# **Addendum and Corrections of the Hardware Manual HM90495-draftv1-6**

Version : hm90495-draftV1-6-corr-x1-00

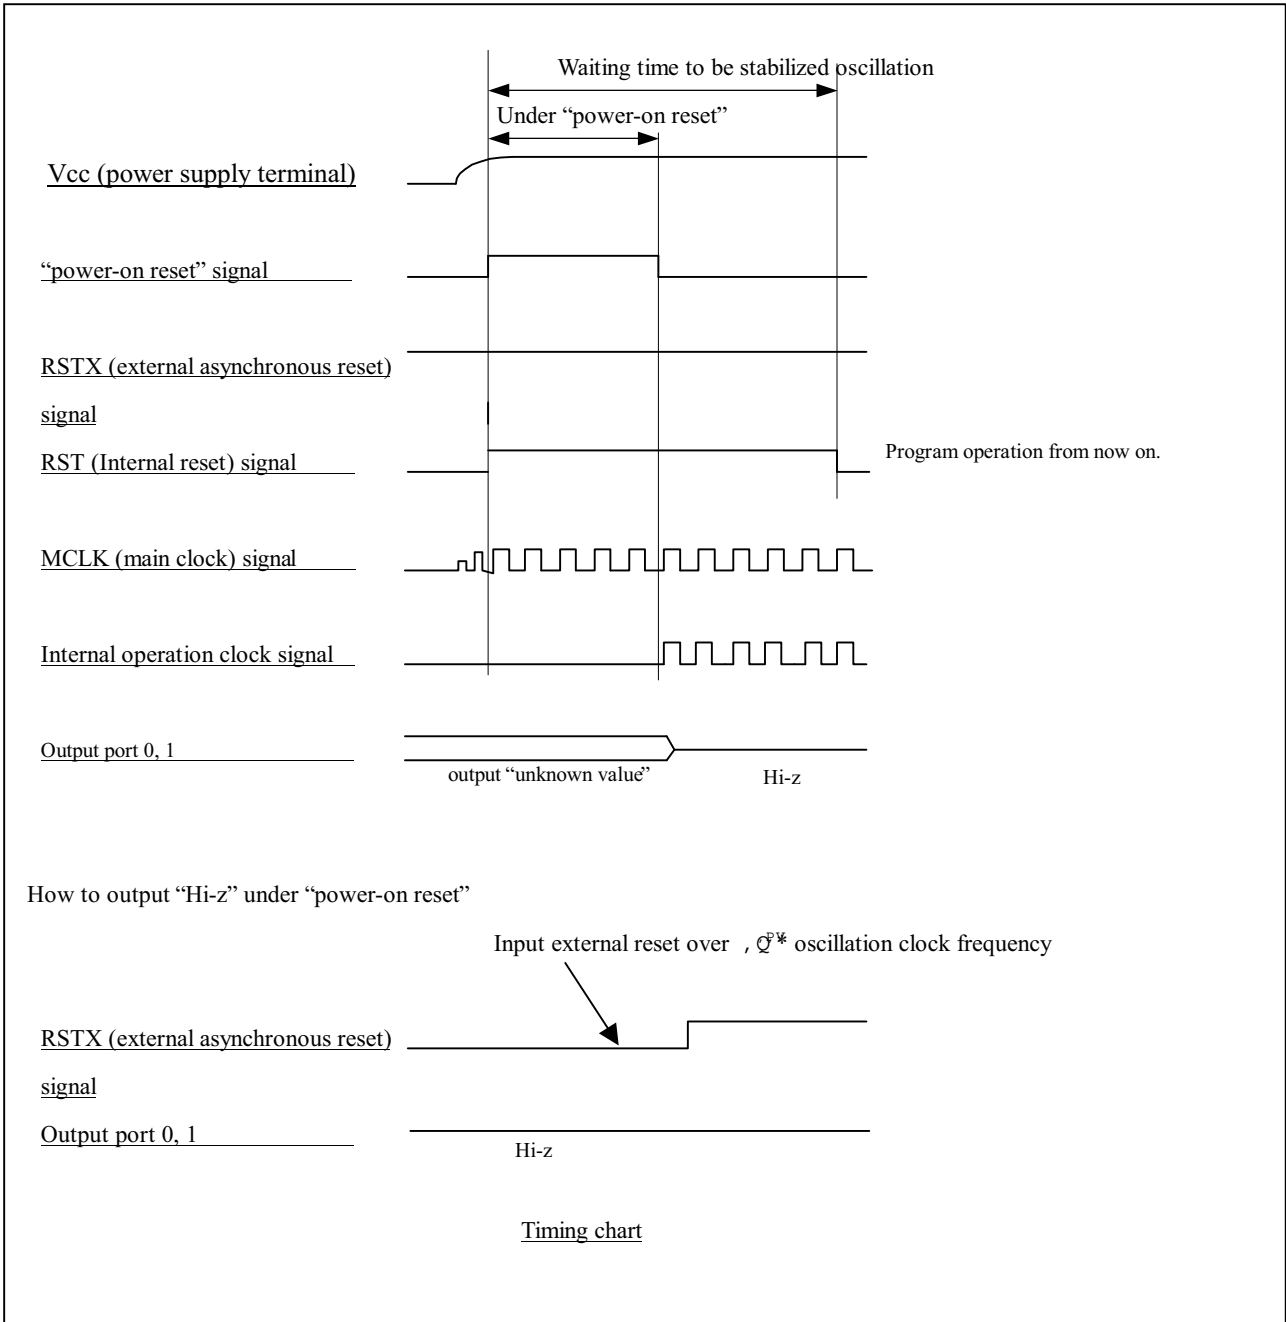
Output "unknown value" of pin 00 to pin 7 and pin 10 to pin 17 terminal, when the power supply is turned on.

Pin 00 to pin 07 and pin 10 to pin 17 terminal become "unknown value" (output "H", "L" level or output "Hi-z" ) under "power-on reset" (stabilized times (2" \* oscillation clock frequency) of clamping circuit for internal power supply), when the power supply is turned on, and when "power-on reset" function operates and RSTX terminal is "H" level.

If you want to output "Hi-z" under "power-on reset", it is applied reset input " "L" level " from external and so pin 00 to pin 07 and pin 10 to pin 17 terminal become "Hi-z" condition during the time.

This workaround will work for Mode pin setting 011 (Single chip, Internal ROM external bus), 110 (Burn\_In ROM), 111 (EPROM mode)

Under "power-on reset"  $2^{17} * \text{oscillation clock frequency}$   
 (8.192ms in case of oscillation clock frequency = 16MHz)

Waiting time to be stabilized oscillation  $2^{17} * \text{oscillation clock frequency}$   
 (16.384ms in case of oscillation clock frequency = 16MHz)
